The Tauranga Airport understands the Port is seeking resource consent for its proposed Stella Passage development through the Fast-Track consenting process. Associated with the Stella Passage Development is the inclusion of additional ship to shore container handling cranes as shown on drawing 270-118 Rev A and 324-239 Rev 0.

NAVIGABLE AIRSPACE DETERMINATION: Ship to Shore Cranes, Sulphur Point Wharf, Tauranga

DETERMINATION OF HAZARD IN NAVIGABLE AIRSPACE

Figure 05-3 VSS Restriction on Proposed Wharf Expansion

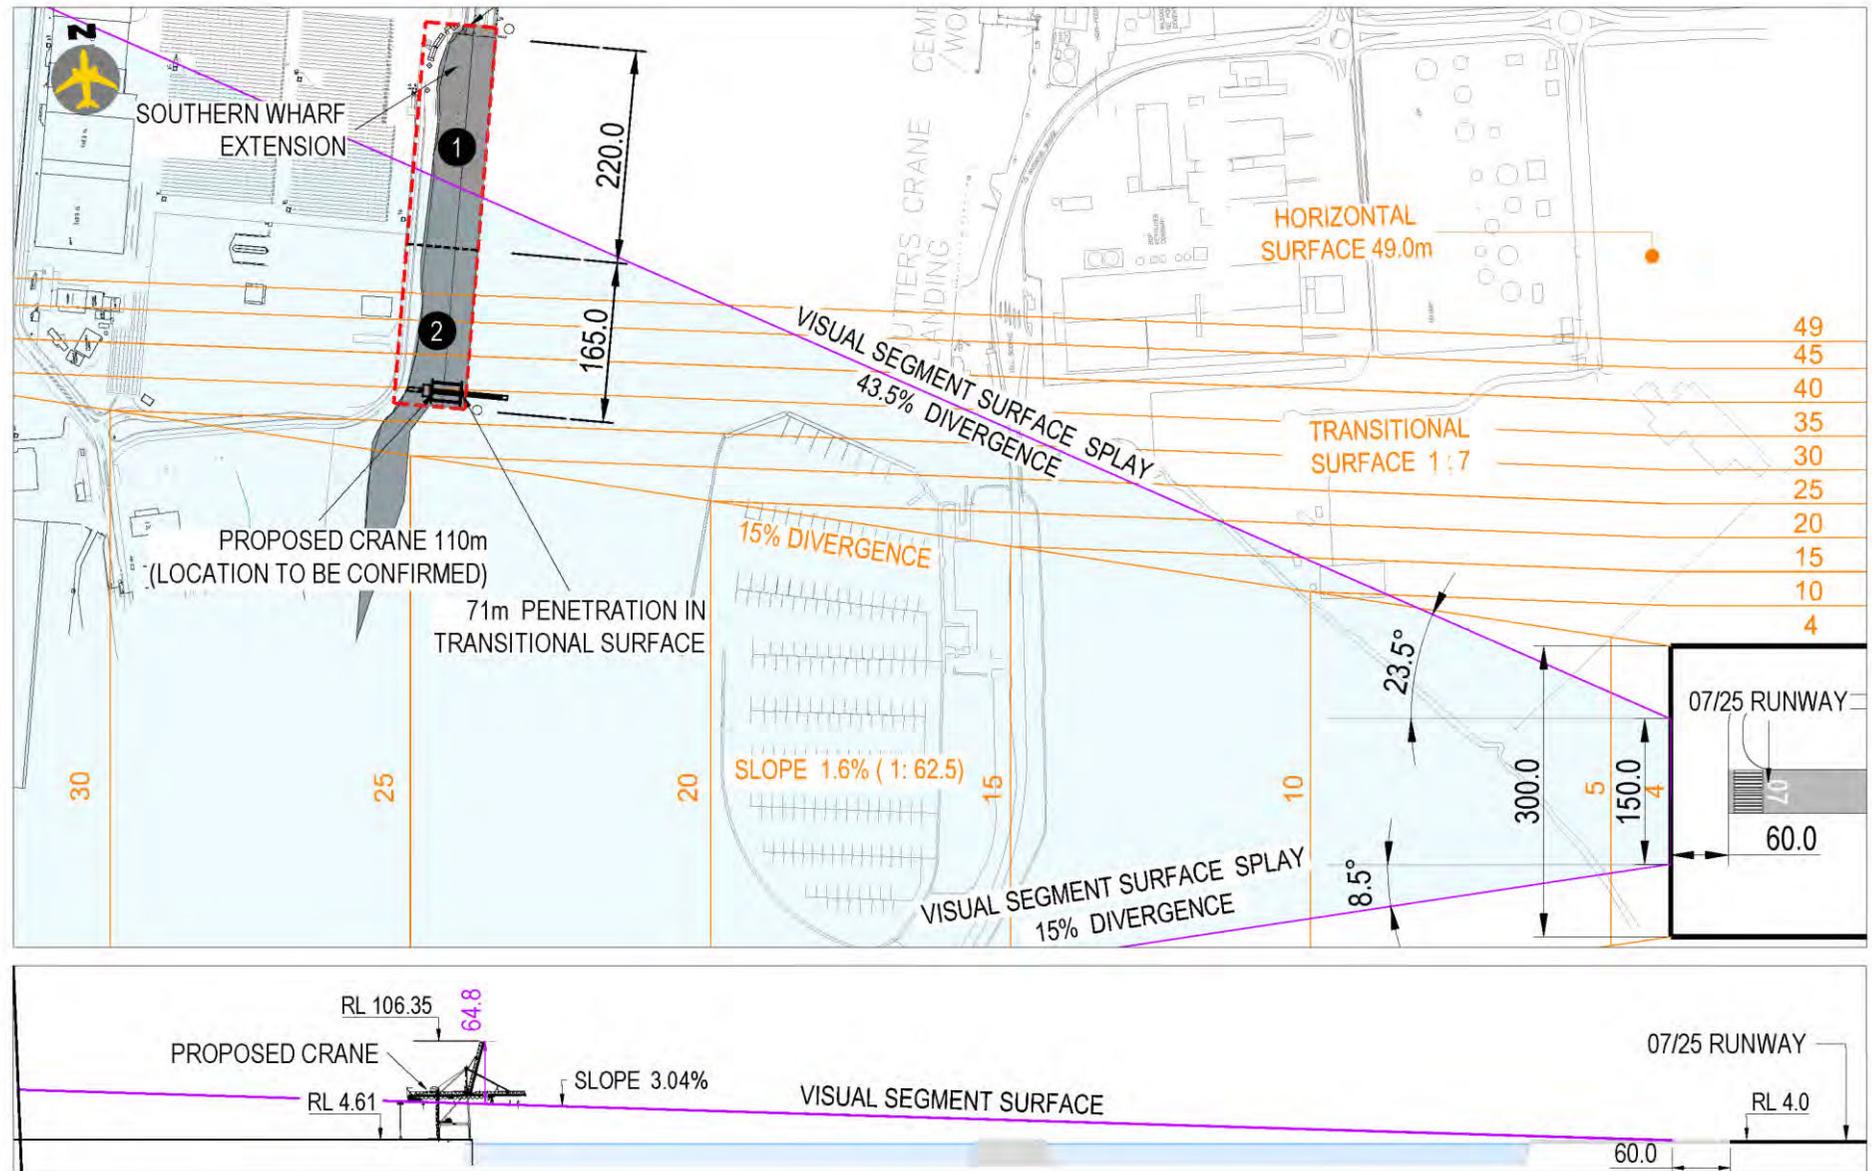
The critical aspect is the requirement that any obstacle must not infringe the VSS, potentially restricting installations in the southern-most third of the initial 220m wharf extension (Area 1) and all of the longer term additional extension to the full 385m extent, denoted as Area 2 in Figure 05-3.

The VSS imposes significant height restriction on more than half of the proposed Port expansion. The VSS is asymmetric to the runway centreline, due to the established flight path having a bias to the north to avoid terrain to the south. The lower profile cranes described in Section 02 above would not be able to fit underneath the current VSS as the available height for a crane would be only approximately 41m. This is illustrated in Figure 05-3.

If the VSS constraint is unable to be resolved by the process of DVOR installation, the only mitigation available would be that TAA could, and have advised that they would revoke the existing NDB/DME RWY 07 approach procedure or the new DVOR/DME RWY 07 approach procedure to remove the VSS constraint.

Figure 05-4 Expected Shape of VSS for a Straight Approach

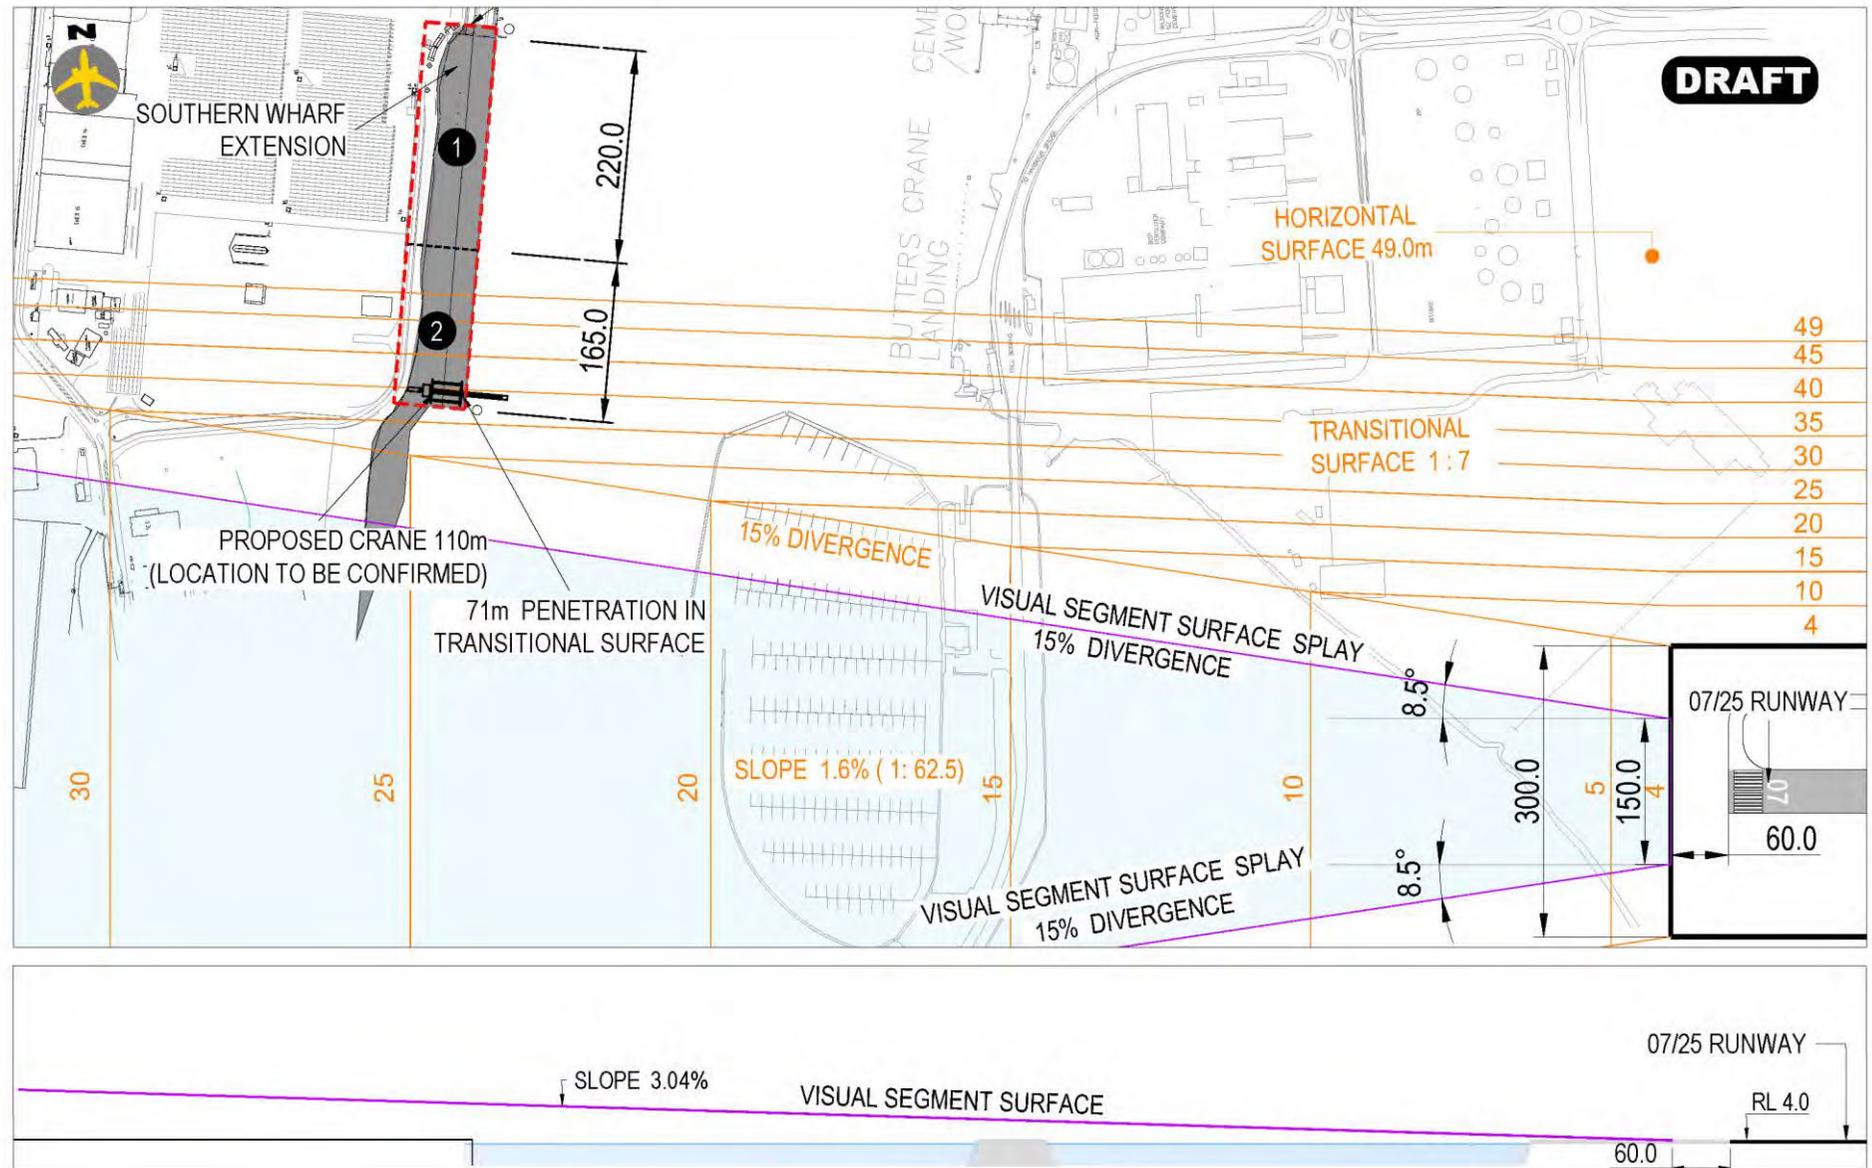
Initial discussions between Airways and the TAA have focused on a site to the south of the sealed Runway 07/25 in close proximity to that runway. It is expected that such a site would enable a straight approach to RWY 07 which would result in a VSS that is “shifted” southwards to achieve a straight-in approach to the runway, which would not overlap the proposed Wharf extension. This is illustrated in Figure 05-4.

Figure 3 - Departure splay RWY 25 and wharf extension

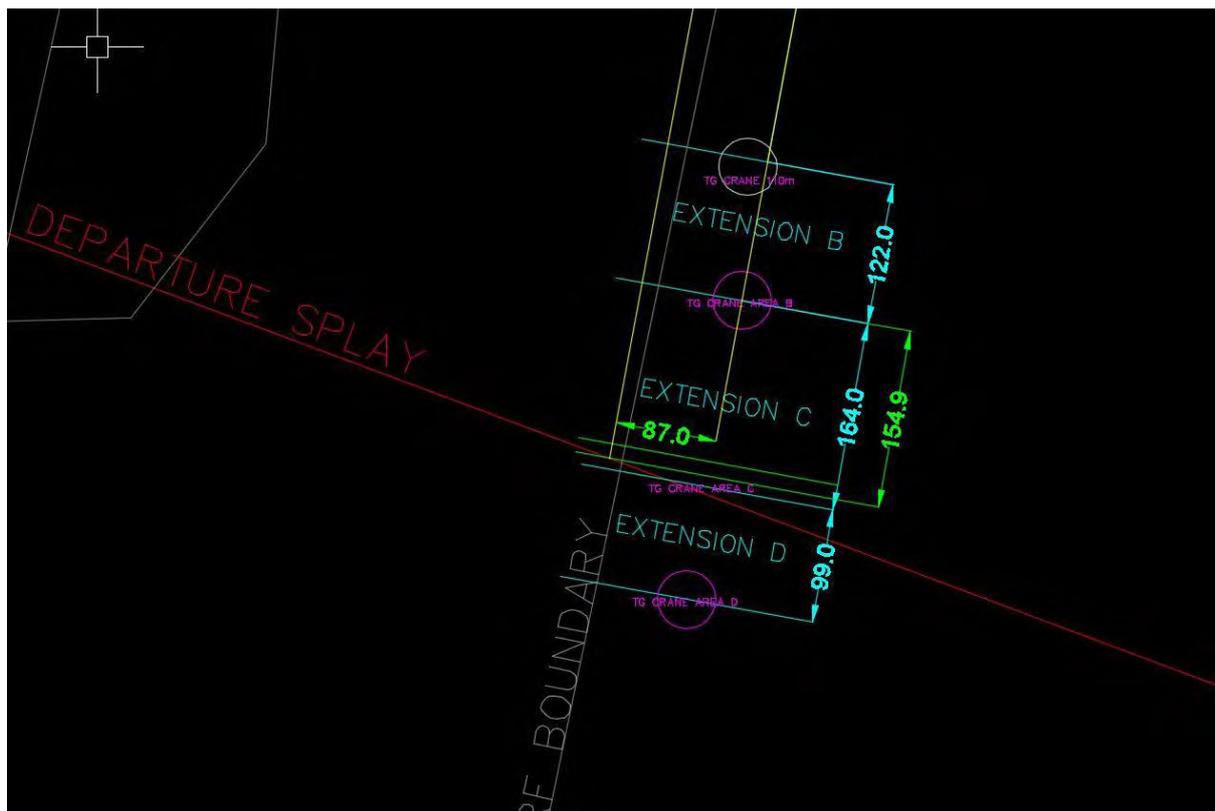
The results indicated that to avoid impacting on the RWY 25 departure procedures, Extension Area C would be required to be extended **no more than 154m to the south from the end of Area B**. See image below:
